Change of material, V-Lock cord retaining feature as standard.

Product Change Notification				PCN 4798			
owner	creation date	release date	released by	change order no	rev	page	0118.2322
hotzar	2016-04-25	2016-04-25	stadelt1	2009853	С	1 of 2

1 Products affected

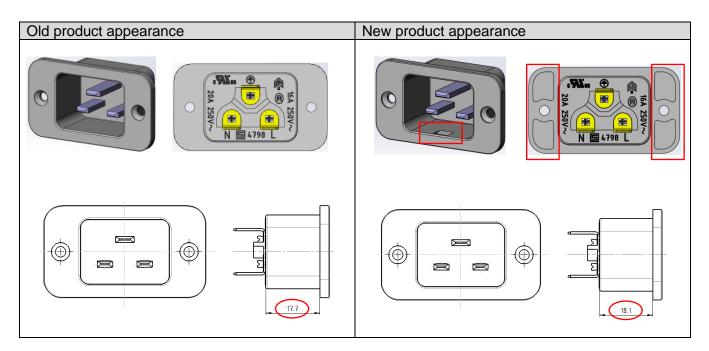
- Material change from PA6 to PA66/6 to pass the enhanced requirements of glow wire test acc. to IEC 60695-2-12 and -13
- V-Lock feature integrated as standard (not an option anymore)
- Flange will have a new form on the back side to improve molding process.

Form	Yes	Yes Socket has notch for V-Lock cord retaining, flange new form on the back side, extended socket dimension.
Fit	Yes	Yes, installation depth is 0.4 mm extended.
Function	Yes	V-Lock feature is standard (not an option anymore)
Production Site	No	There is no change of the production site
Product Label	No	No label change
Customer Action	No	Check installation depth in the application. Change SCHURTER part number if affected.

4798.9000.15 🖙 4798.9000	4798.9100.15 🛋 4798.9100	4798.9200.15 🖙 4798.9200
4798.9000.21 📥 4798.9000	4798.9100.21 📥 4798.9100	4798.9200.21 📥 4798.9200

The change takes effect in ww 16/2016 (Production Date code 1616 or higher on label). For new orders, the order numbers are continuing to use according to the data sheet. The delivery of the new variants is dependent of sales.
